BRIEL'S REPLICA-1 PLUS microSD STORAGE CARD COMPATIBILITY MODS

1. MODIFICATIONS ON REPLICA-1 PLUS

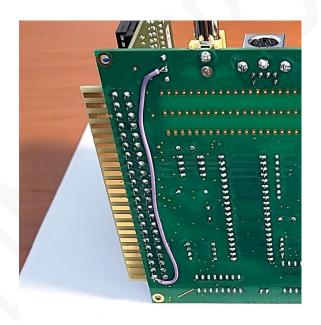
This modification is necessary since, because of the more modern hardware, a signal is missing on the expansion connector and the corresponding pin is not connected to anything. To override this lack, it is essential to **connect pin 1 of the expansion connector to +5V** as illustrated in this picture:
